A30 Chiverton to Carland Cross TR010026

8.1 COMMENTS ON RELEVANT REPRESENTATIONS

Volume 8

February 2019

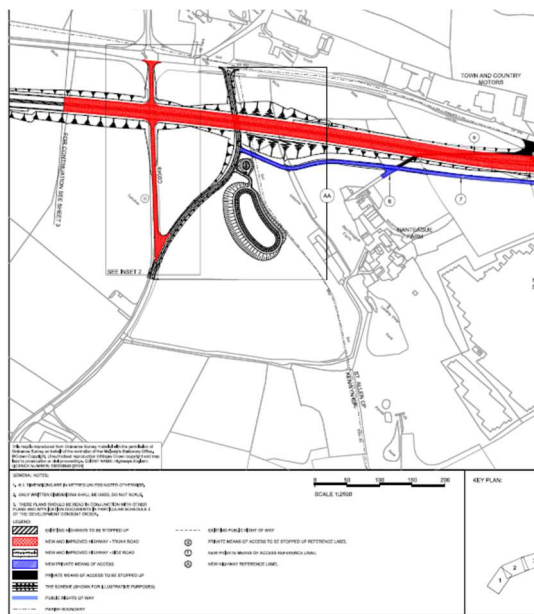
Access is required to the rain gauge at Allet Nanteague Farm Monday to Friday from 08:00 to 17:00. We would need access to quality check the equipment on site, general maintenance and to repair any faults that may arise with the gauge.

Environment Agency Relevant Representation	Highways England Response
<p>1.3 Solution We request that the proposer provides further details to demonstrate how access to the site of our rain gauge will be provided and maintained during construction along with the associated timeframe for these works.</p> <p>We consider that maintained access to our rain gauge during construction could be secured through the addition of a new protective provision or requirement in the DCO, whichever is most appropriate. We are happy to provide any further detail that is necessary in this regard.</p>	<p>Access off the Tresawsen Road is not affected by the scheme. The current agreement with Cornwall Council is that the Tresawsen Road would be kept open to traffic at all times. If this was to be closed from the existing A30, there would be an alternative route from Shortlanesend Road to the south.</p> <p>Highways England will work with the contractor to ensure that access to the rain gauge is maintained during the construction stage.</p> <p>Volume 6.4 Environmental Statement Appendix 16.1 - Outline CEMP, Table 16-3 Record of environmental actions and commitments (REAC) will be amended to ensure access to the rain gauge will be maintained during construction to secure this commitment with the contractor.</p>

This is correct. The **Book of Reference Part 3** refers to the Environment Agency in respect of Rights of access to the rain gauge granted by a lease agreement dated 19 June 2012.

Access requirements have been noted on Sheet 4 of the Rights of Way Access Plans (Document Reference 2.5

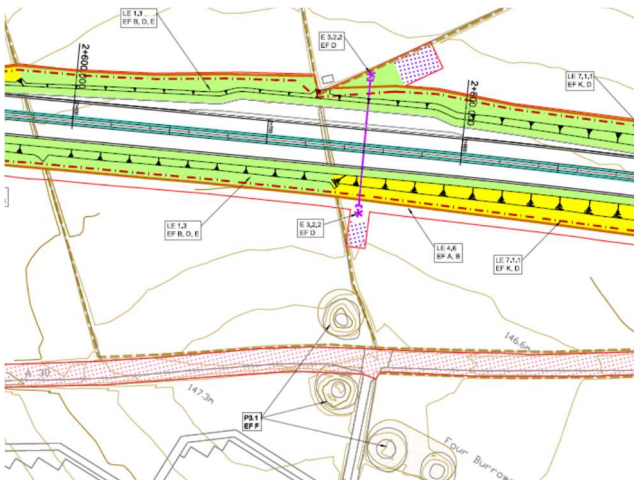
<p>5. 6.11.25 Four burrows (SM 29602; NHLE no. 1016054)</p>	
<p>The assessment provided classifies the impact of the new route on the north of the northernmost barrow as permanent Moderate Adverse, it concludes that there will be no change to the remaining barrows in the group. The cumulative assessment is then concluded to be an overall Neutral impact. Historic England does not consider that the cumulative assessment takes due regard of the permanent adverse impact on this group of nationally important barrows which should, in the assessment, be considered as a group and the impacts not atomised by assessment of each barrow in isolation.</p>	<p>The point is understood. Volume 6, Document Ref 6.2 ES Chapter 6 Cultural Heritage, Section 6.11 Assessment of Effects reports in para 6.11.25 “The scheme would realign the A30 as a dual carriageway approximately 50m north of the northernmost barrow of the group. This would remove the rural setting of this barrow, leading to a permanent moderate adverse impact on its significance; this would result in a Moderate Adverse significance of effect. The existing A30 would remain in situ as a local route, and therefore the current division of the barrow group would continue. This would constitute no change to the setting of the three barrows to the south of the A30, resulting in a Neutral significance of effect.”</p> <p>The northern barrow is physically separated from the remaining barrows by the existing A30 and would be the only barrow in the group to experience an adverse effect.</p>

Historic England Relevant Representation	Highways England Response
	<p>The views outwards from the group is only one component of setting that contributes to the significance of the barrows; there is also a substantial role played by the immediate setting of the barrows as a group. This interrelationship between the barrows would be unchanged by the proposed scheme, and therefore the impact upon the northernmost barrow cannot be said to influence the significance of the remaining barrows.</p> <p>For visual reference: Environmental Masterplan showing Four Burrows in relation to scheme.</p>

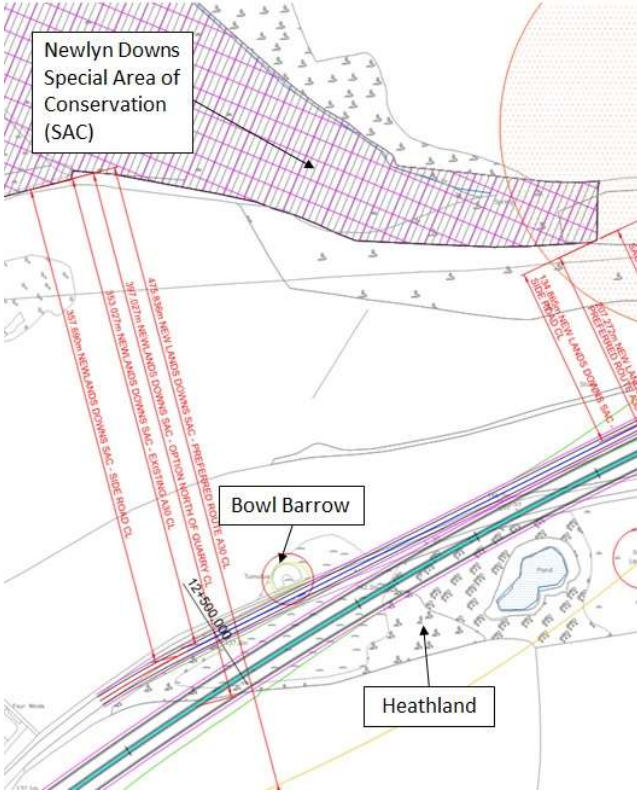
<p data-bbox="161 1550 1327 1615"><i>11. Two bowl barrows 290m and 375m north of Higher Ennis Farm (SM 32902; NHLE no. 1017050)</i></p>	
<p data-bbox="161 1657 788 1995">We note the assessment of impact and the engineering requirement for the northernmost of these barrows as a result of the chosen route. However, we would draw to the Examining Authority's attention the fact that the original proposed route, which crossed the existing A30 some way to the west, did not require this work. In our opinion, the selection of the route in this area will need to be clearly justified as it has been demonstrated through the development</p>	<p data-bbox="802 1657 1439 1825">The Preferred Route was evaluated near Nanteague Farm and Carland Cross following the statutory public consultation on the preferred route Highways England undertook 29 January 2018 to 12 March 2018.</p> <p data-bbox="802 1848 1439 2042">An alternative alignment further north of the Preferred Route was developed, retaining the Carland Cross Junction at its current position. Figure A below shows the northern alignment and highlights the environmental constraints in the area.</p>

Historic England Relevant Representation	Highways England Response
<p>phase that alternative options, less harmful to the historic environment, may exist.</p>	 <p>Figure A Northern Alignment at Quarry with 1:2 embankments at a max height of 13m</p> <p>The northern alignment would have been beneficial from a geotechnical perspective. This is due to: the higher elevation of the route; the reduced depth of cutting; slacker quarry slopes at the northern side of the quarry; and the movement further away from ‘Journey’s End’ mining area to the SW of the quarry. However, although reduced, it was acknowledged that there would still be risks associated with working in such close proximity to the quarry.</p> <p>Although beneficial from a geotechnical perspective, the alignment also has a number of adverse effects:</p> <ul style="list-style-type: none"> • It could result in significant adverse effects on the European Designated Newlyn Downs Special Area of Conservation (SAC). An air quality assessment undertaken at Key Stage 2 Options Appraisal, concluded that a northern option would result in increased nitrogen deposition at Newlyn Downs SAC and a new exceedance of the upper band critical load up to 195 m into the SAC. The critical load for the site is 10 - 20 kg N/ha/yr and the current deposition

Figure B Option of Lowering Carland Cross by 0.5m

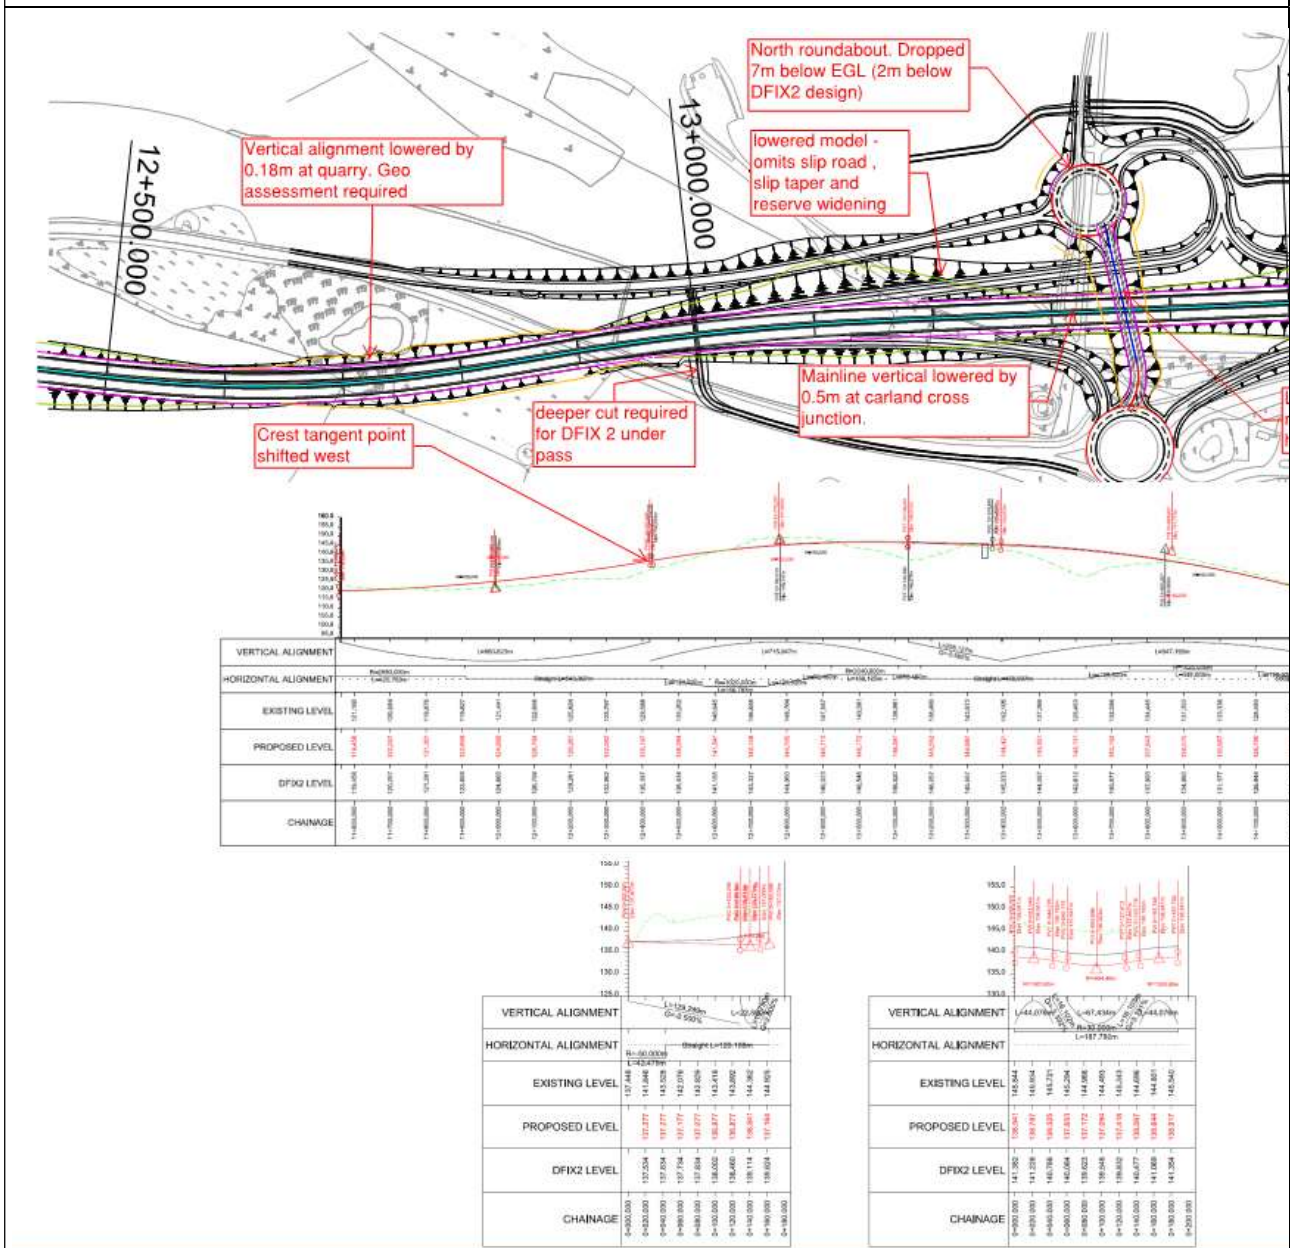
<p>Historic England's main concern is that regardless of the issues outlined above, the current proposals for the new route will result in a very high level of harm to the significance of the Warrens barrow scheduled monument that will not, in our opinion, be sufficiently offset by the potential for benefits gained from re-unification of the cemetery. The location of barrows is a significant element of their importance, usually located for maximum impact and visibility in both long and short views, they provide and illustrate the importance of landscape to the life and burial practices of prehistoric peoples. Since, in Historic England's opinion, there remains potential for further discussion to identify alterations to engineering details that would reduce the level of harm caused we would recommend that the Examining Authority encourage the applicant to continue to pursue discussion regarding this element of the scheme with Historic England in the interest of reducing its environmental impact.</p> <p>We have previously requested a detailed examination of the engineering options for this junction on the basis that relatively minor changes could potentially affect major impacts and reductions in harm in relation to this issue. We would recommend that the Examining Authority urge the applicant to undertake a serious engineering options appraisal regarding the levels at the proposed new Carland Cross junction.</p> <p>In addition we would recommend further consideration of whether there are opportunities to achieve better value for public money and at the same time a reduced environmental impact</p>	<p>The engineering options at Carland Cross and Warrens Barrow were considered and the outcome of the results were shared with Historic England on the 12/06/2018. The following documents were provided:</p> <ul style="list-style-type: none"> • Nanteague Farm and Carland Cross Options Report • Photomontage from the barrow south of the existing A30 at Carland Cross • Before and after view from Warrens Barrow, looking towards Newlyn Down • Retaining Wall options report <p>An extract from the "Nanteague Farm and Carland Cross Options Report" is provided below:</p> <p>Historic England's consultation response has identified a negative effect of the scheme at Carland Cross due to impacting on significant views to and from the barrow group at Newlyn Downs. According to Historic England, this could only be mitigated against by lowering the alignment at Carland Cross and so this option has been explored during the design development.</p> <p>The route is highly constrained horizontally and vertically in this area with very little additional land-take justified without impacting on the barrow group, abandoned quarry pond to the south, the wind farm to the north or the Newlyn Down European Designated Site (SAC) to the north.</p> <p>The main constraint for lowering the alignment at Carland Cross are the knock-on effects that will</p>

Historic England Relevant Representation	Highways England Response
<p>in heritage terms in the proposals for this junction.</p>	<p>occur at the existing abandoned quarry. Lowering the alignment at Carland Cross by anything more than 0.5m, would push the earthworks out into the quarry pond which would result in the infilling of the pond. This would also result in a larger retaining structure at the round barrow immediately south of the proposed route at Ch 12900.</p> <p>The option of lowering the alignment by 0.5m has been explored by Highways England and is shown in Figure B on the next page.</p>
